SUBJECT: AMENDMENT NO. 108 TO FACILITY OPERATING LICENSE NO. DPR-74  
(TAC NO. 65677)

The Commission has issued the enclosed Amendment No. 108 to Facility Operating License No. DPR-74 for the Donald C. Cook Nuclear Plant, Unit No. 2. The amendment consists of changes to the Technical Specifications in response to your application dated August 15, 1988.

This amendment revises moderator temperature coefficient, shutdown margin, and engineered safeguards actuation requirements to reflect the steamline break analysis performed by Advanced Nuclear Fuels Corporation for D. C. Cook Unit 2.

SAFETY EVALUATION BY THE OFFICE OF NUCLEAR REACTOR REGULATION  
RELATING TO THE STEAMLINE BREAK ANALYSIS  
AND AMENDMENT NO. 108 TO FACILITY OPERATING LICENSE NO. DPR-74  
INDIANA MICHIGAN POWER COMPANY  
DONALD C. COOK NUCLEAR PLANT, UNIT 2  
DOCKET NO. 50-316

FIGURE 3.1-3 REQUIRED SHUTDOWN MARGIN

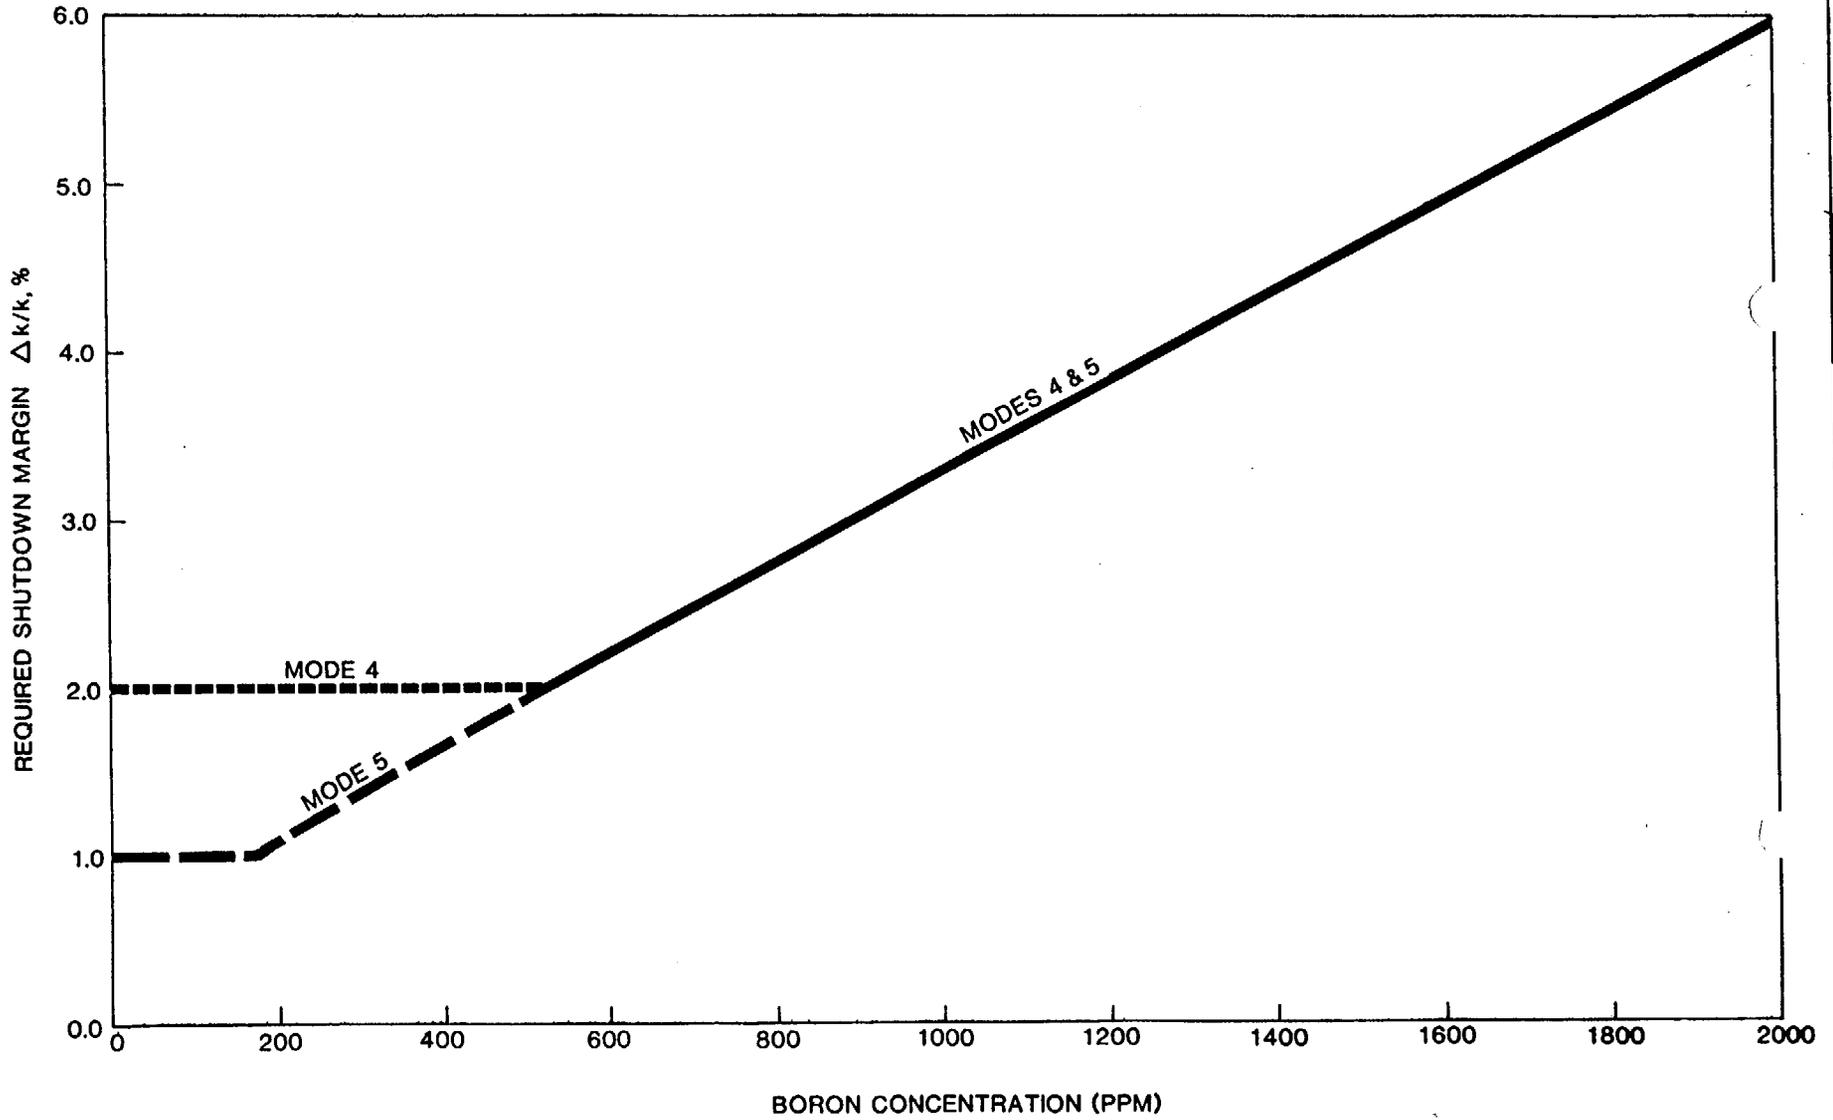
1. Greater than or equal to  $2.0\% \Delta k/k$  when operating with one or more Reactor Coolant Loops in accordance with Specification 3.4.1.3.
2. Greater than the value shown in Figure 3.1-3 when operating with no Reactor Coolant Loops but one or more Residual Heat Removal Loops in accordance with Specification 3.4.1.3.

1. Greater than or equal to  $1.0\% \Delta k/k$  when operating with one or more Reactor Coolant Loops in accordance with Specification 3.4.1.3.
2. Greater than the value shown in Figure 3.1-3 when operating with no Reactor Coolant Loops but one or more Residual Heat Removal Loops in accordance with Specification 3.4.1.3.
